Charlotte-Mecklenburg Planning, Design, & Development

SUBJECT: Administrative Approval for Petition No. 2020-099 D.R. Horton

Mallard Creek Townhomes
Charlotte, NC
Amended Site Plan

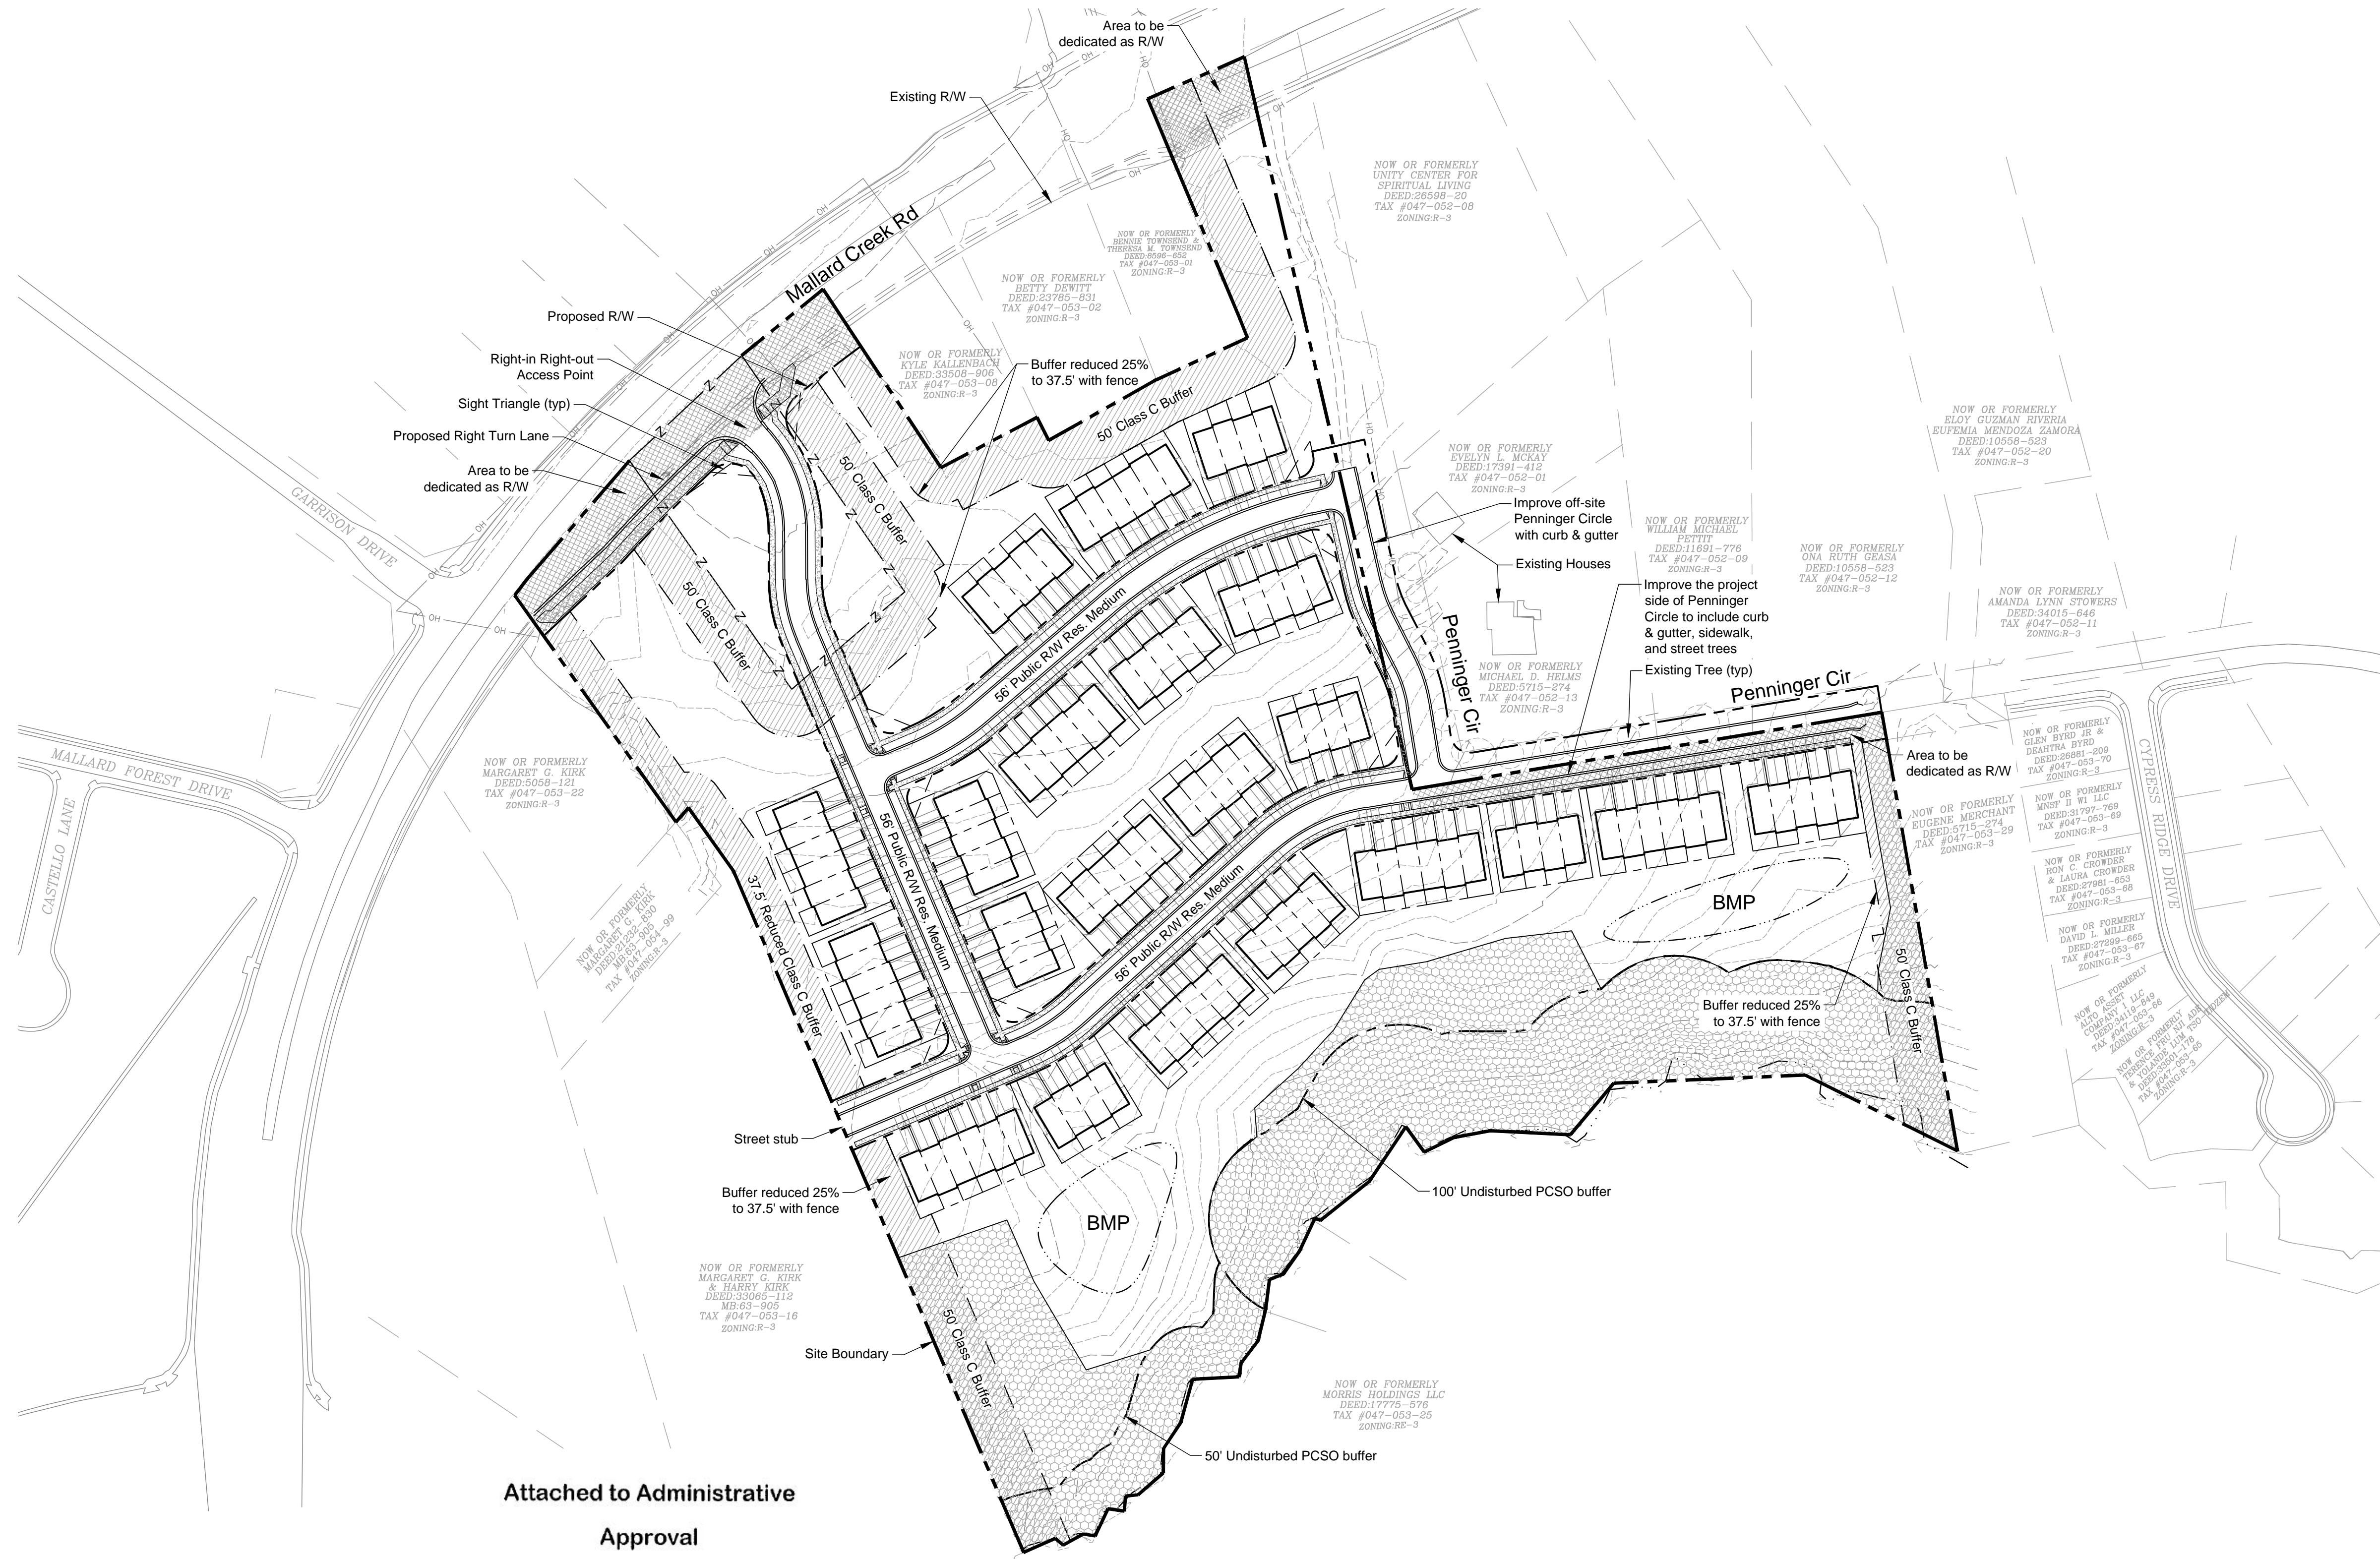
Attached is the revised site plan for the petition above. This request allows the modification of the proposed site plan as listed below. Since these changes do not alter the intent of the development and meets the requirements of the Charlotte Zoning Ordinance Section 6.207 Alterations to Approval, minor changes, I am administratively approving this plan. Please use these plans when evaluating requests for building permits and certificates of occupancy.

- To allow modification to the site for a public street connection.

- The site plan complies with the conditional notes and still meets the intent of the original approval by the City Council.
